ADDENDUM No. 1

Park Hill School District

2024 Masonry Projects

March 27, 2024

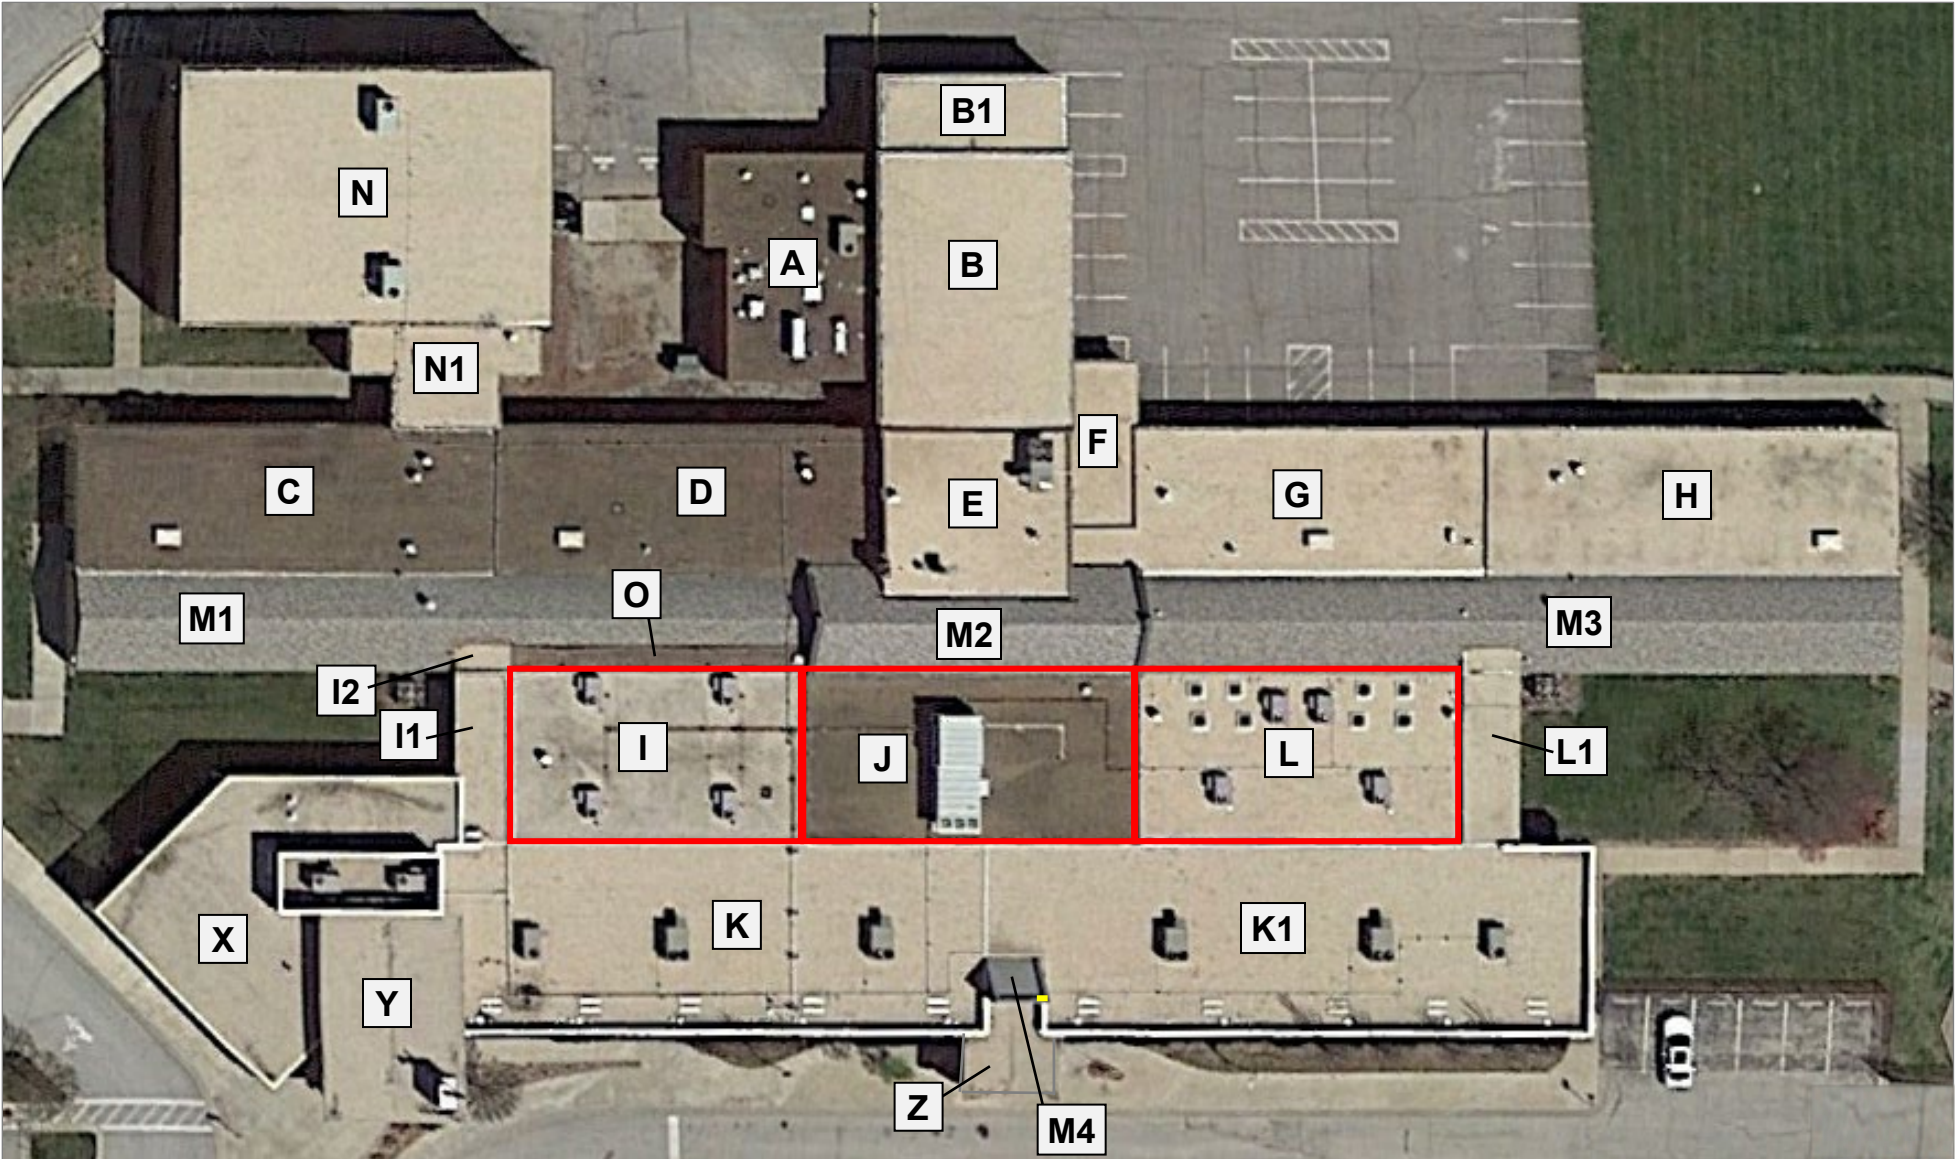
- 1. There are two trash enclosure, only include the main enclosure closest to the school.
- 2. Clarification: The rectangular wall vents and associated PVC drain pipes extending through the north and south elevation walls below Roof D, ARE NOT included in this work. These vents and pipes will be removed and infilled by others during interior renovation this summer.

- a) The wall vents and pipes on the north elevation wall below Roof B ARE included in this project and all sealant around these projections perimeters need to be remove and replaced.

- 3. Use Tremco’s Spectrum 800 for the asphalt to brick joints around the gym, Roof F.
- 4. Remove and dispose of lightning rods and cables on chimney above Roof B.

- 5. Install new 24-gauge pre-finished metal cap over the chimney above Roof B.
 - a. The exterior metal fascia shall cover the existing concrete fascia and extends down onto the brick.

- b. Fascia shall be secured with a 22-gauge continuous cleat.
 - c. Add new wood as needed to provide proper attachment and slope to the new metal cap.

Park Hill High School

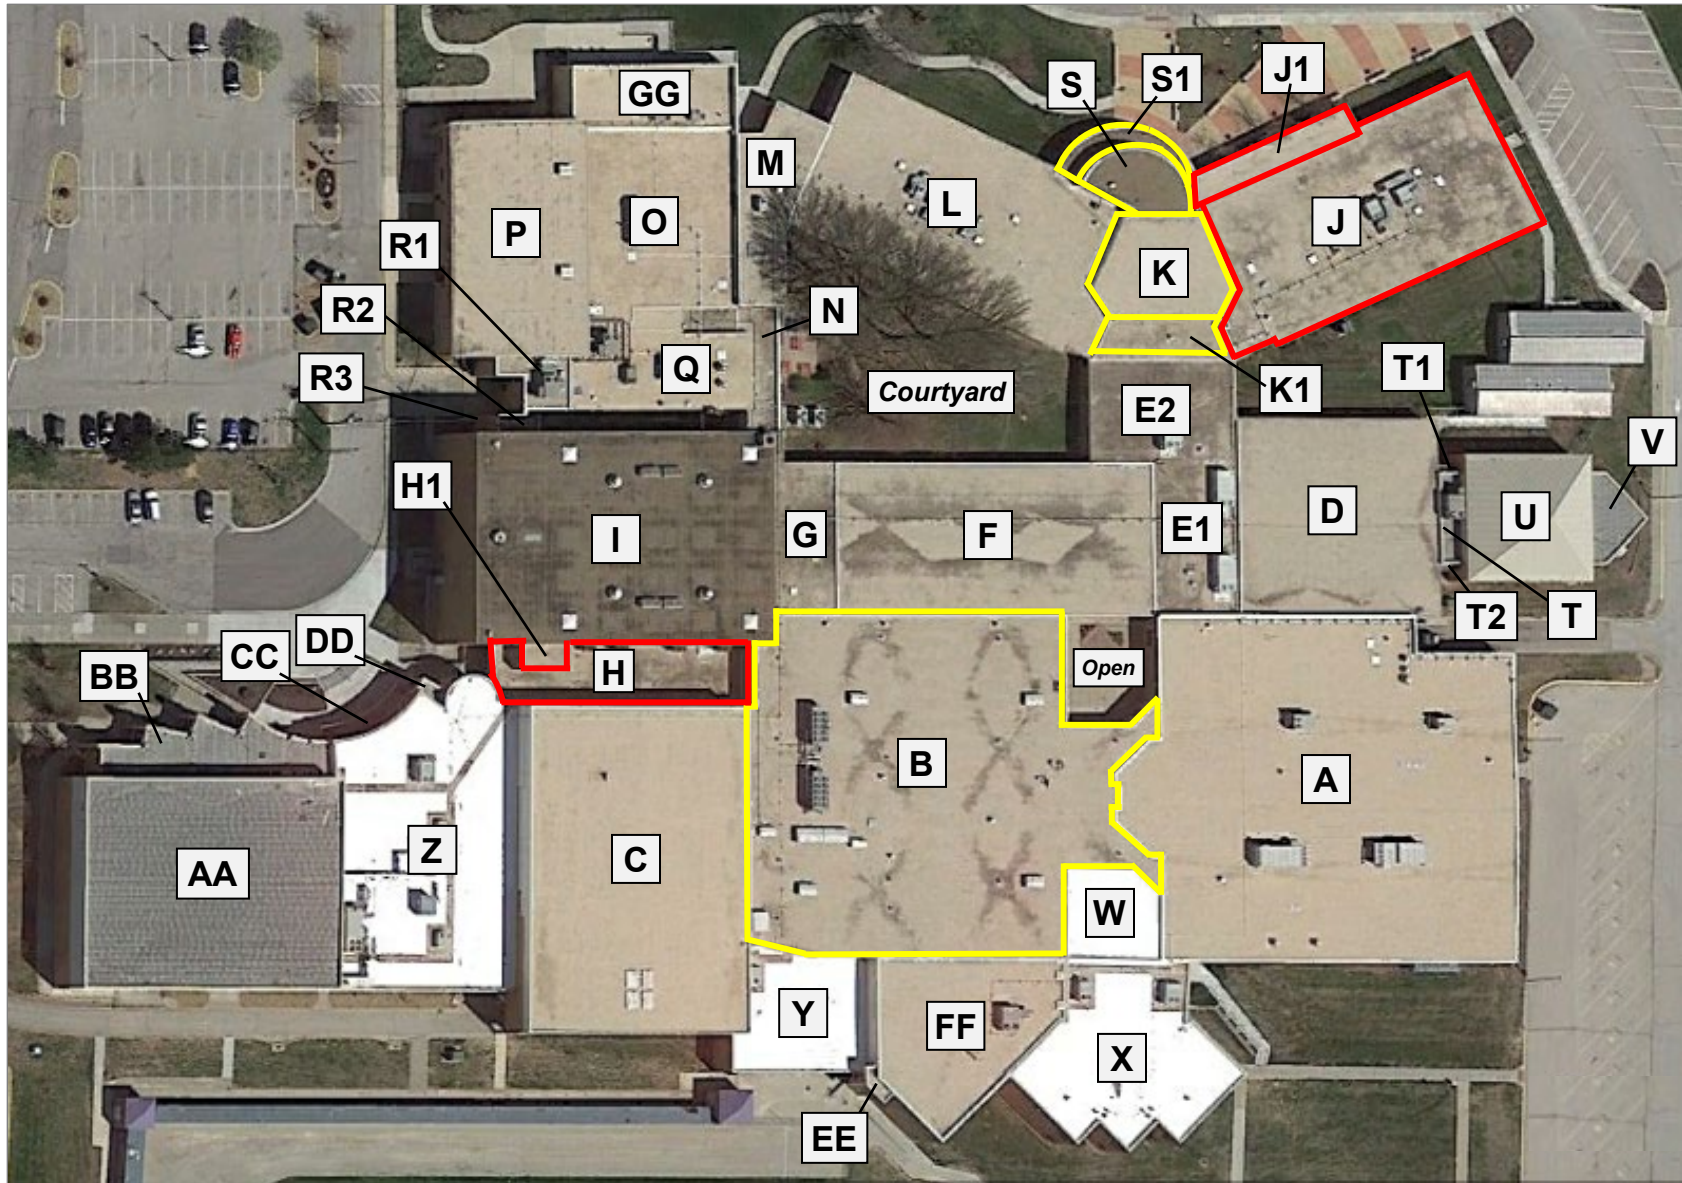
- A. Park Hill High School
 - 1. Remove and dispose of lightning rods and cables on chimney above Roof I, and extending vertically down the north elevation wall below Roof I.
 - 2. New metal cap for the chimney above Roof I shall include:
 - a. An exterior metal fascia that covers the existing concrete fascia and extends down onto the brick.
 - 3. Prior to installing the new metal wall panels at the east wall of courtyard/pit, north of Roof I;
 - a. Install a self-adhering air vapor control membrane to cover 100% of the wall.

- b. Include matching metal corner closures to properly terminate metal wall panels.
- 4. Remove obsolete light fixtures at the NE and NW corners of the north wall below Roof I.
 - a. Fill voids in brick with new brick and/or matching sealant.
- 5. Replace/install new, brick to wood sealant joint under wood fascia along top edge of north wall below Roof I.
- 6. Replace/install new, brick to soffit panel sealant joint on the walls below Roof P.
- 7. At the large courtyard, south elevation wall; remove two conduits at west end and fill voids with new brick and/or matching sealant.
